# SERVICE BULLETIN

SB1202

: T2100E

: Windshield surround - rubber seal change

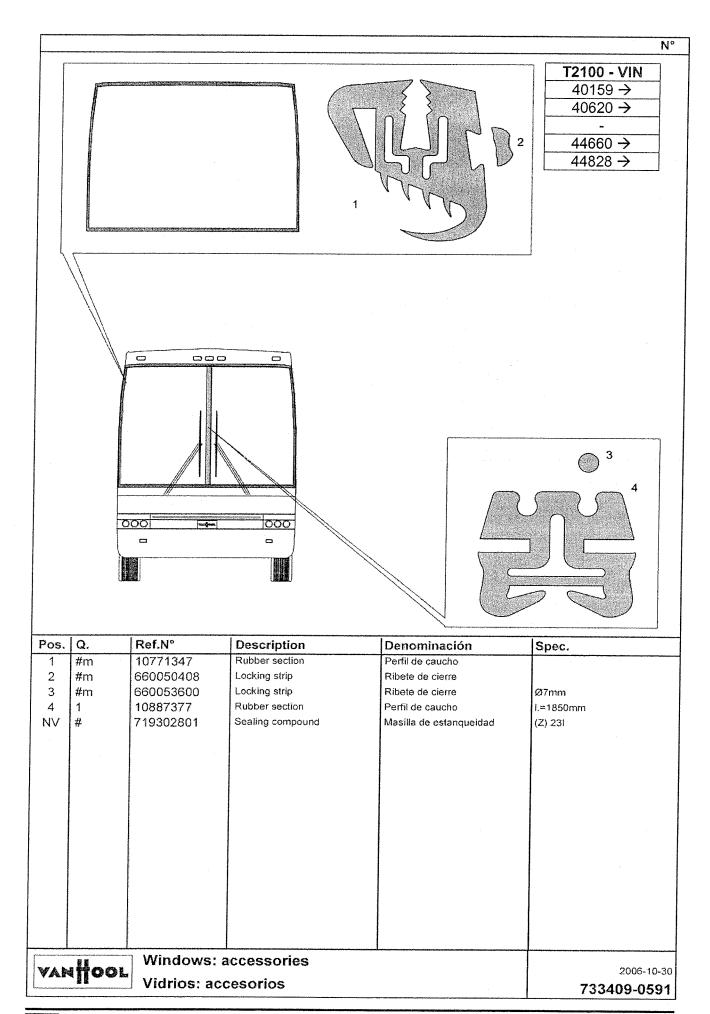
2. Having the same shape and almost identical overall dimensions as the old one, the new seal features a wider groove to clear the windshield mounting flanges (see Figure 1, overleaf). This allows for improved fit and quality of installation, resulting in enhanced finish and appearance in general.

VH reference Description		Qty.
VH 660064402	Seal, windshield surround, 3 mm gap, see Figure 1	#
VH 660050408	Strip, locking for VH 660064402	#
VH 660064451	Molding, windshield center post	#
VH 660053600	Strip, locking for VH 660064451	#
VH 719302801	Adhesive, Sika 221	#

VH reference Description		Qty.
VH 10771347	Seal, windshield surround, 6 mm gap, see Figure 1)	#
VH 660050408	Strip, locking for VH 660064402	#
VH 660064451	Molding, windshield center post	#
VH 660053600	Strip, locking for VH 660064451	#
	Adhesive, Sika 221	#
